Access Compliance Report

Public Rights-of-Way

(Curb Ramps)

Intersection ID: 44487	Main Street: REAMES_RD	Cross Street: FINN_HALL_AV	Location: S
ADA ID: 3487C75D3899	Ramp Type: Perp	Initial Pass/Fail: Fail	Overall Compliance: No
Codes/Mitigation Info/Possible Solution		Field Measurements/Component Compliance	
Severity Score: 33.75

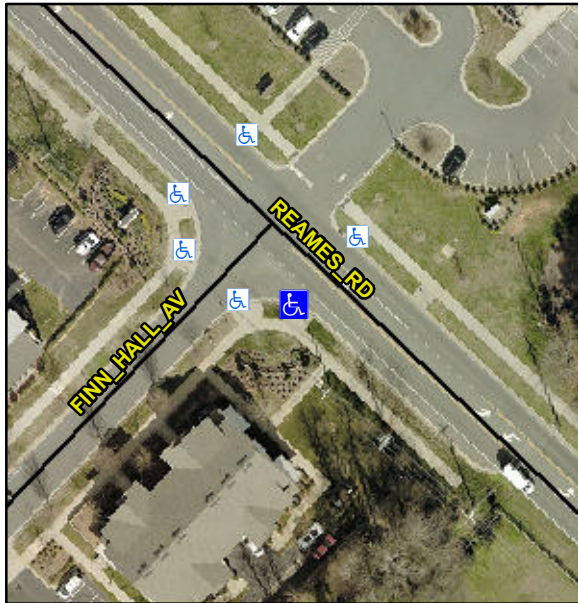
Not Found, R304.5.1, R304.5.3

Compliance	Description	Data	Compliance	Description	Data
N/A	Ramp Length (in)	94.5	Yes	Ramp Slope (%)	8.2
No	Ramp Width (in)	45.0	No	Ramp XSlope (%)	8.0
N/A	Flare Type LT	N/A	N/A	Flare Type RT	N/A
N/A	Flare Slope LT (%)	N/A	N/A	Flare Slope RT (%)	N/A
N/A	Flare Traversable LT?	N/A	N/A	Flare Traversable RT?	N/A
N/A	Landing Length (in)	N/A	N/A	DWS Provided?	N/A
N/A	Landing Width (in)	N/A	N/A	DWS Contrast?	N/A
N/A	Landing Slope (%)	N/A	N/A	DWS Length (in)	N/A
N/A	Landing X Slope (%)	N/A	N/A	DWS Full Width?	N/A
N/A	Landing Curb? (Y/N)	N/A	N/A	DWS Offset (in)	N/A
N/A	Shared Landing?	N/A			
N/A	Gutter Ponding?	N/A	N/A	Gutter Slope (%)	N/A
N/A	Gutter Lip Ht (in)	N/A	N/A	Gutter X Slope (%)	N/A
N/A	Painted X Walk1?	No	N/A	Painted X Walk2?	N/A
	X Walk 1 Direction	To NE		X Walk 2 Direction	N/A
N/A	X Walk 1 Width (in)	N/A	N/A	X Walk 2 Width (in)	N/A
	X Walk 1 Slope (%)	2.4		X Walk 2 Slope (%)	N/A
	X Walk 1 X Slope (%)	3.1		X Walk 2 X Slope (%)	N/A

Remove & Replace Entire Ramp.
